COMMITTEE OF THE WHOLE JUNE 19, 2012

**ZONING BY-LAW AMENDMENT FILE Z.11.022
SITE DEVELOPMENT FILE DA.11.070
1559586 ONTARIO INC., C/O OSKAR GROUP
WARD 1 - VICINITY OF KEELE STREET AND KILLIAN ROAD**

Site Plan

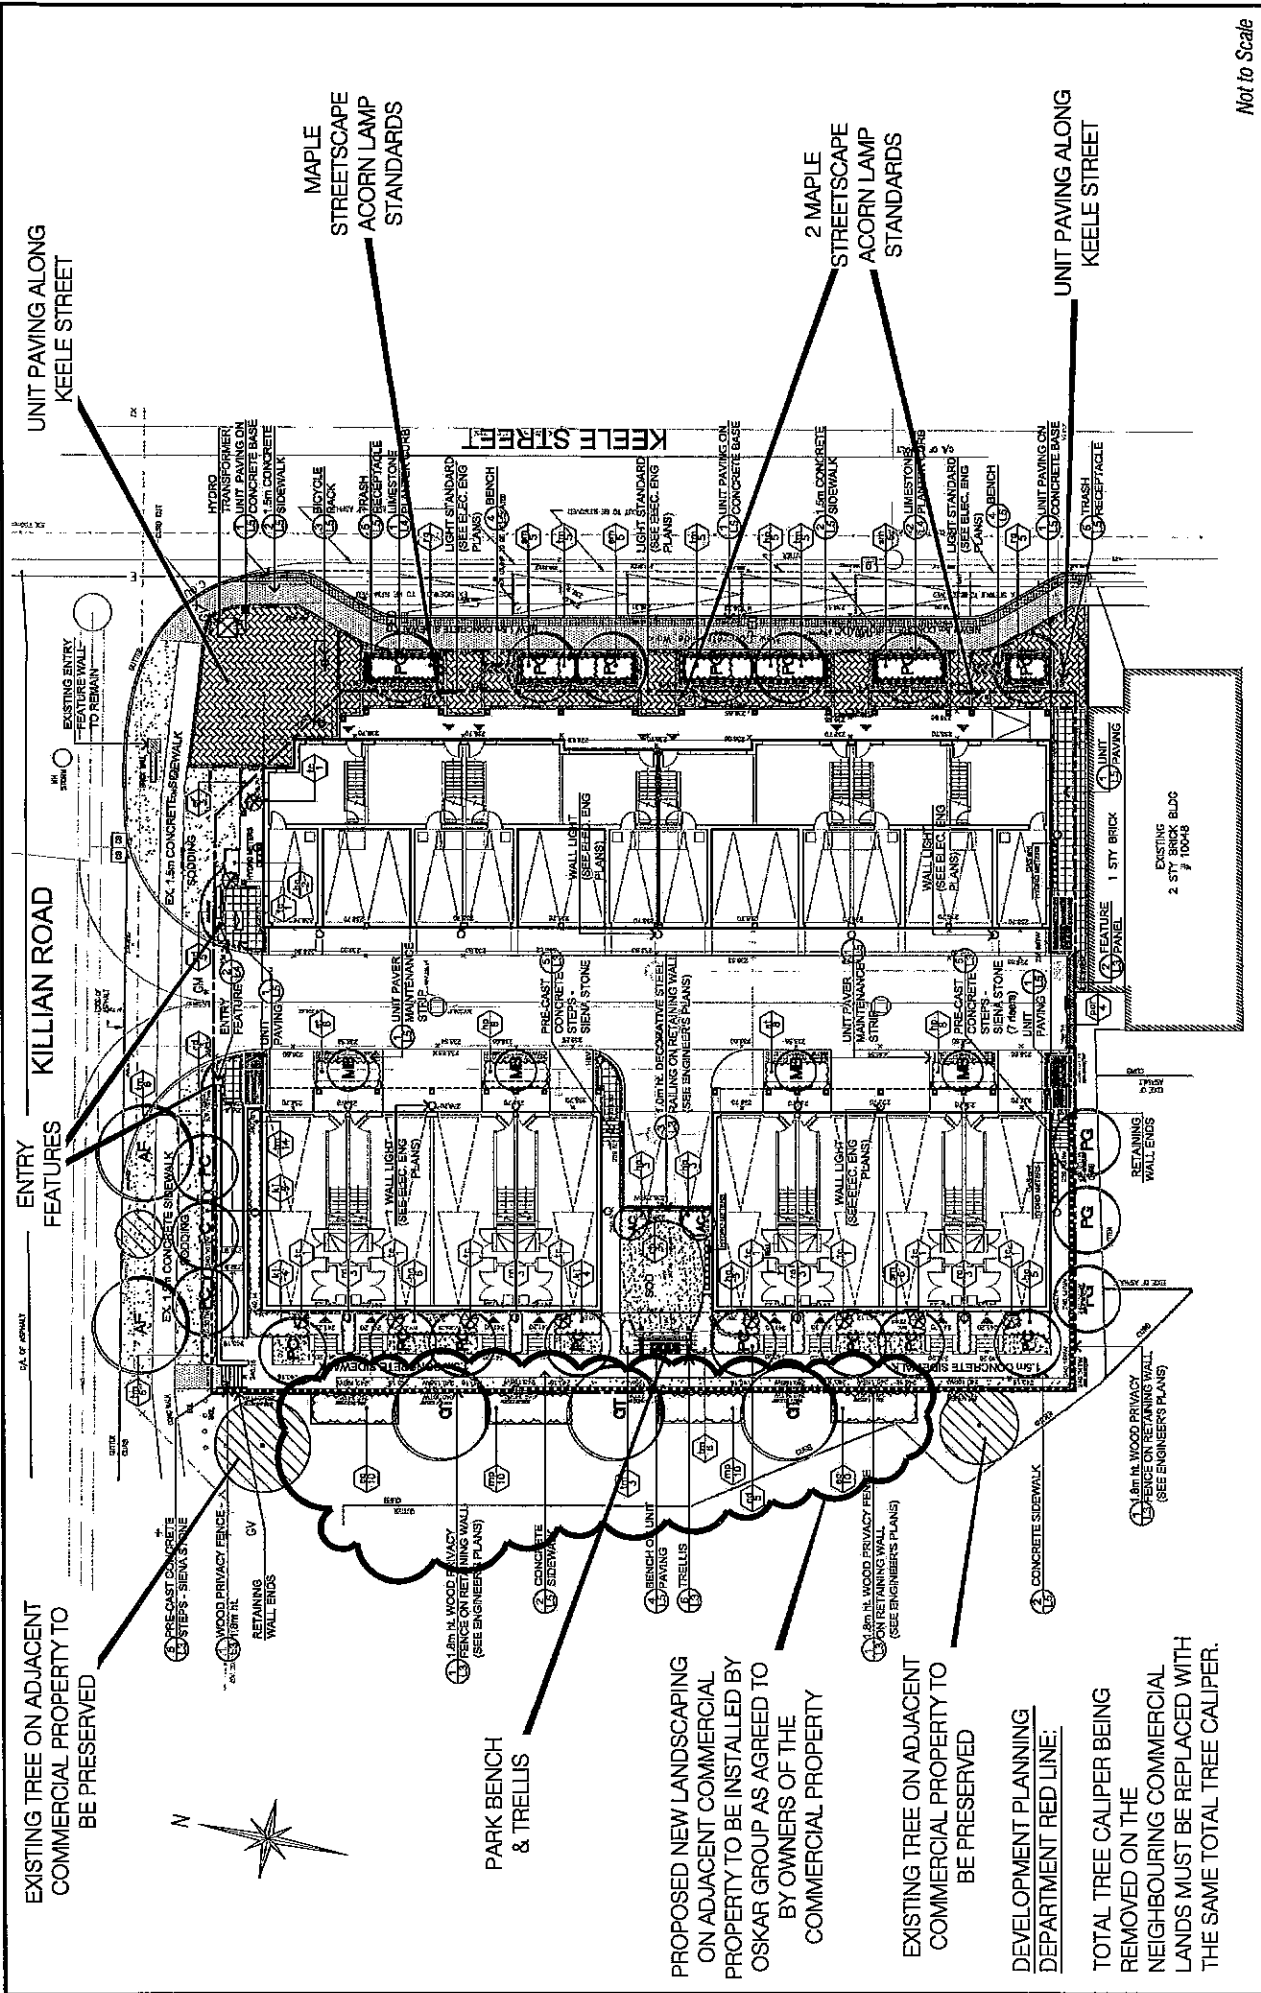
Two barrier-free ramps have been incorporated into the site design. One is integrated into the streetscape along Killian Road in front of Building "B" (Attachment #5) for access to Buildings "B" and "C". The other responds to the Ontario Building Code requirements and the Vaughan Development/Transportation Engineering Department comments and is located at the southern

The site plan process allows, in part, for the review of the internal traffic flow. A turnaround in the rear private road has been included along with a 1.3m off-set for more convenient vehicle maneuvering. The Vaughan Public Works Department (waste collection truck maneuverability) and the Vaughan Development/Transportation Engineering Department (fire route and vehicular movements) have reviewed the site plan and are satisfied that the plan meets the requirements of traffic flow and service delivery within the internal laneway.

The Development Planning Department has reviewed the proposed fence along the west property line and portions of the south property line, shown on Attachment #6, and is satisfied that it meets Vaughan's property standards requirement. The site will be developed as a standard condominium corporation and maintenance of the fence will be the responsibility of the Condominium Corporation. The Owner will also be providing landscaping on the adjacent commercial lands, as part of the private agreement with the adjacent commercial plaza owners, which is described further in the landscape plan section of this report.

Landscape Plan

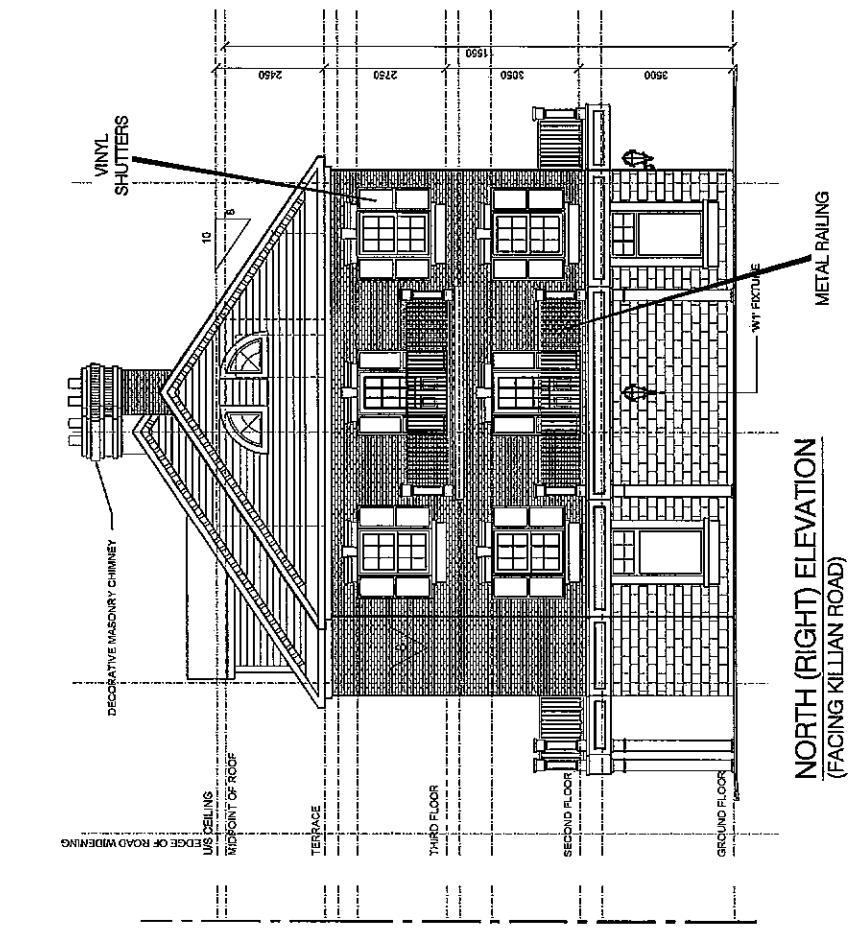
It was determined through the review of the landscape plan that the proposed retaining wall and privacy fence would create a compact soil condition that would not be conducive to the viability of the existing trees on the adjacent commercial plaza. Through a private agreement with the owners of the neighbouring commercial plaza, the Applicant, in accordance with the tree preservation plan, will be replacing some of the trees and adding shrubs, as identified on Attachment #6. Upon further review of the landscape plan, the Development Planning Department has communicated to the Owner that the total tree caliper that is being removed on the neighbouring commercial lands must be replaced with the same total tree caliper on the commercial lands. Specifically, the total tree caliper proposed for removal is equivalent to approximately 156cm. The landscape plan has been redlined accordingly on Attachment #6, as agreed by the Owner in a memorandum dated June 4, 2012, and has been included in the recommendation section of this report.

DEVELOPMENT PLANNING DEPARTMENT RED LINE:

TOTAL TREE CALIPER BEING REMOVED ON THE NEIGHBOURING COMMERCIAL LANDS MUST BE REPLACED WITH THE SAME TOTAL TREE CALIPER.

Block "B" & "C" - Side Elevations

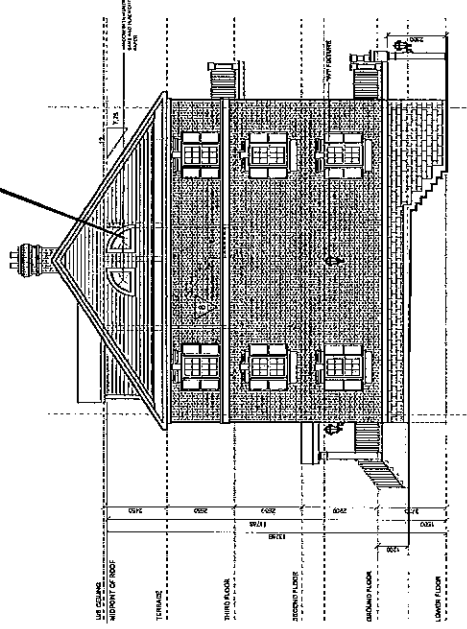
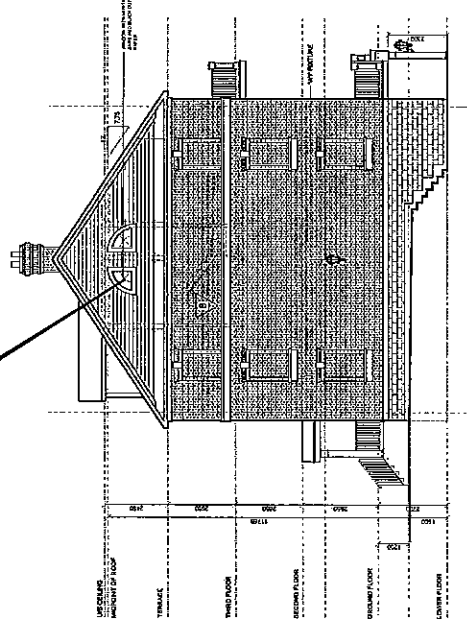
- f) That no blind windows will be permitted on any elevation, including the Killian Street facades, except for the quarter circular windows at the gable ends on the attic, provided that the muntin bars are of the exterior type;
